MIL-D-81609C(AS)  
 AMENDMENT 1  
 10 SEPTEMBER 1986

MILITARY SPECIFICATION  
 DETECTING SET, MAGNETIC AN/ASQ-81(V)

This amendment forms a part of MIL-D-81609C(AS), dated 23 July 1981, and is approved for use by the Naval Air Systems Command, Department of the Navy, and is available for use by all Departments and Agencies of the Department of Defense.

\*FIGURE 4. RANDOM VIBRATION SPECTRUM

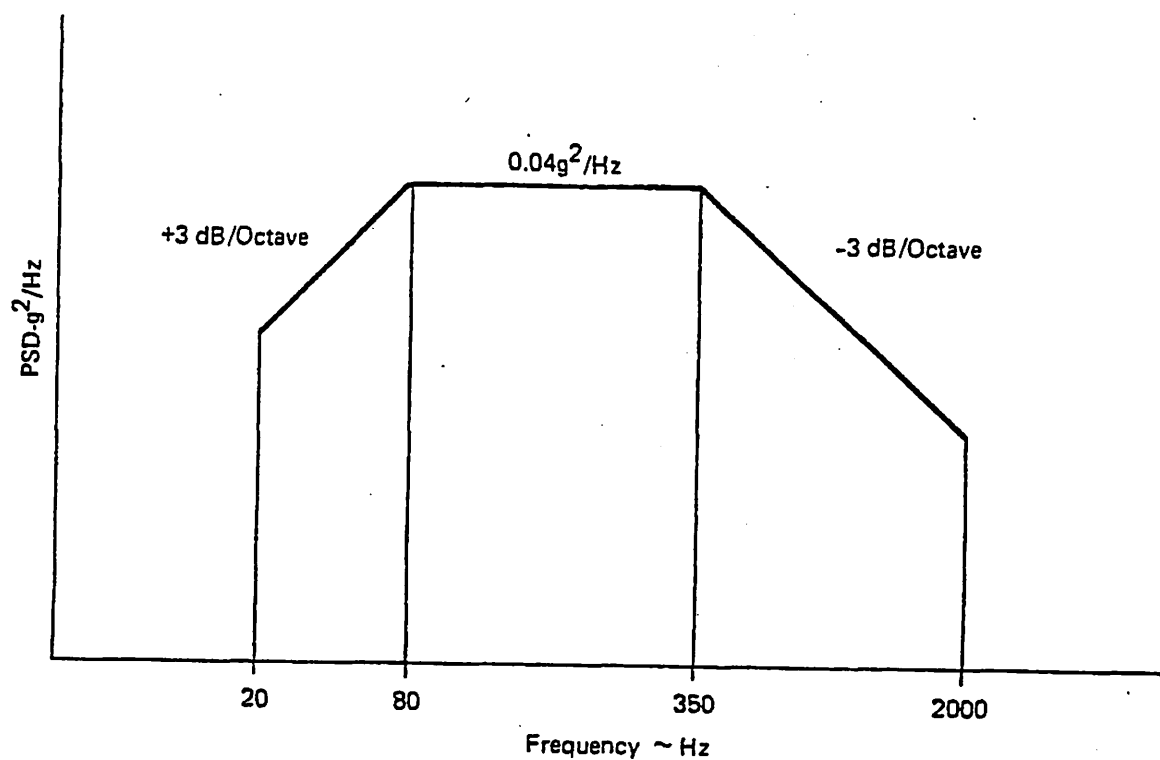
\*4.4.1.3 Manufacturing Screening - Each equipment shall undergo 10 minutes of random vibration per Figure 4. The vibration shall be applied perpendicular to the plane of the printed circuit boards in a minimum of two axis for all electronic modules, SRA's, and WRA's including SRA's on the reeling machine. If different planes exist, the vibration shall be applied to each axis for 10 minutes. After completion of random vibration, each module, SRA and WRA shall be examined carefully to determine that materials and workmanship

\*Figure 4 - Add Figure 4.
